1963 Corvette: Service News: Hydraulic Steering Hose Interference

Subject: 1963 Corvette Hydraulic Steering Hose Interference

Source: Chevrolet Service News

Date: December, 1962

Fig. 1—Adding Strap to Corvette Steering Hoses

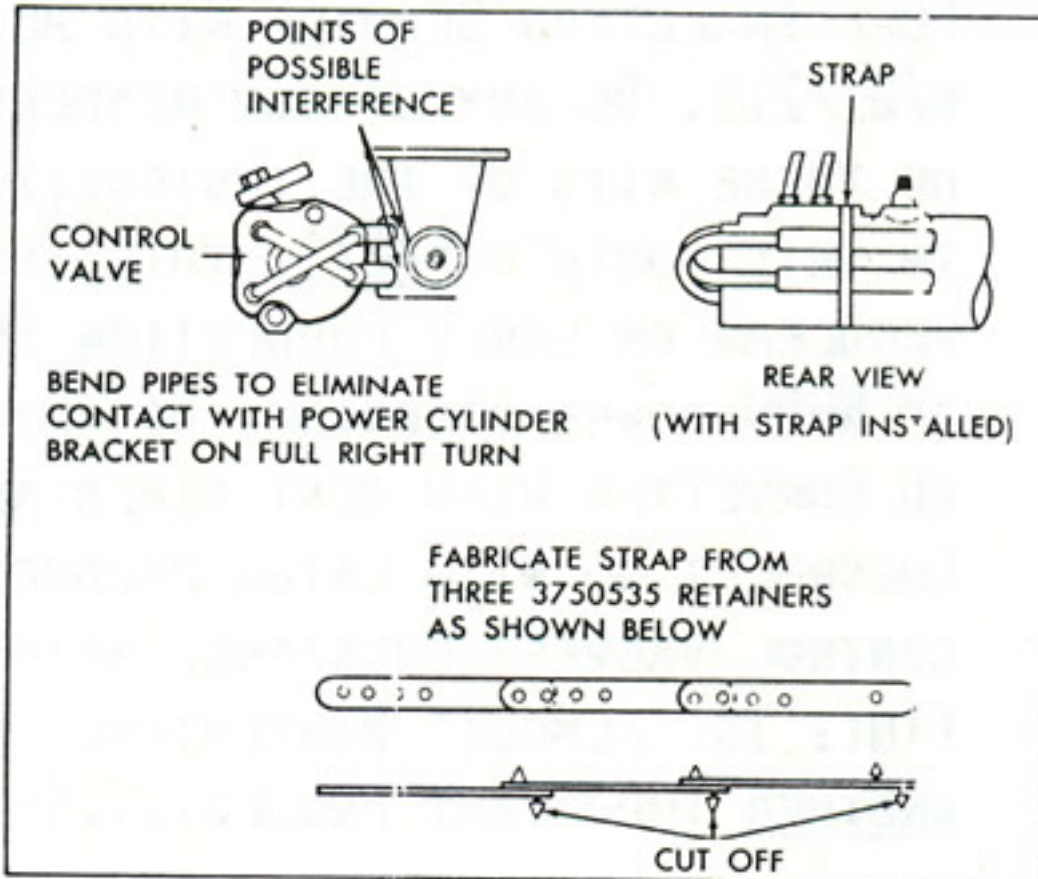
On early production 1963 model Corvette vehicles, interference, in some cases, may be encountered between the hydraulic steering control valve power cylinder hoses and the hydraulic steering cylinder frame bracket. This would occur when the wheels are moved into a full right turn. If this condition is experienced, the hose pipes at the control valve should be bent to provide clearance and then strapped with three Part No. 3750535 Retainers as shown in Figure 1.
